**2873N0 Eliminating drive symptoms: Reworking crankshaft pulse sender
(Engine difficult to start and rough-running/SY2113)**

Model Year: **As of 2012 up to 2014 Sports Cars (9x1)**

Figure 1

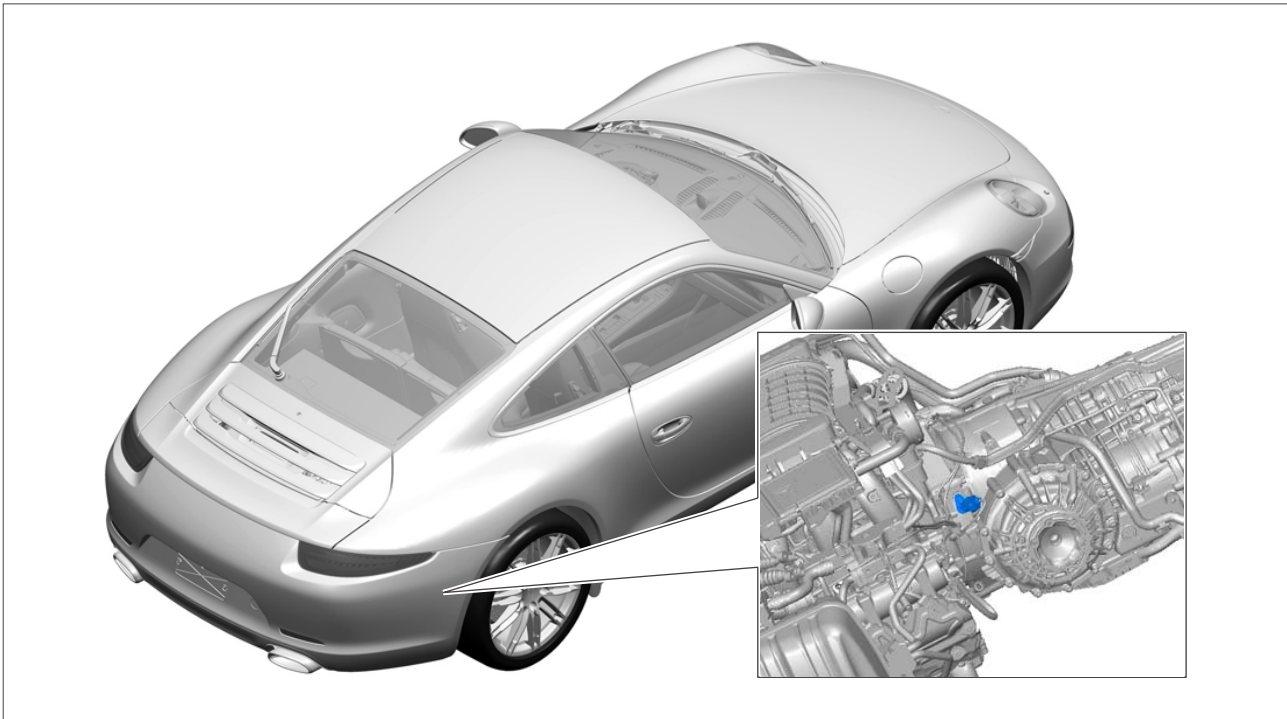
The crankshaft pulse sender signal can be misinterpreted under certain operating conditions due to unfavourable tolerances between the crankshaft pulse sender (also referred to as 'speed sensor') and sensor wheel.

As of 12 September 2013, a spacer is fitted on the crankshaft pulse sender as a tolerance compensation measure.

Before doing any other work, check that **a spacer** is already fitted on the crankshaft pulse sender.

1. **Before doing any other work**, check that the spacer is already fitted on the crankshaft pulse sender.
You can do this using a mirror, for example.
⇒ **Spacer is already fitted: End of action required.**
2. Remove crankshaft pulse sender, see Workshop Manual
⇒ '287319 Removing and installing crankshaft pulse sender - section on "Removing"'.
3. Fit spacer (Part No. 991.606.912.00) between the transmission housing and crankshaft pulse sender.
4. Install crankshaft pulse sender, see Workshop Manual ⇒ '287319 Removing and installing crankshaft pulse sender - section on "Installing"'.
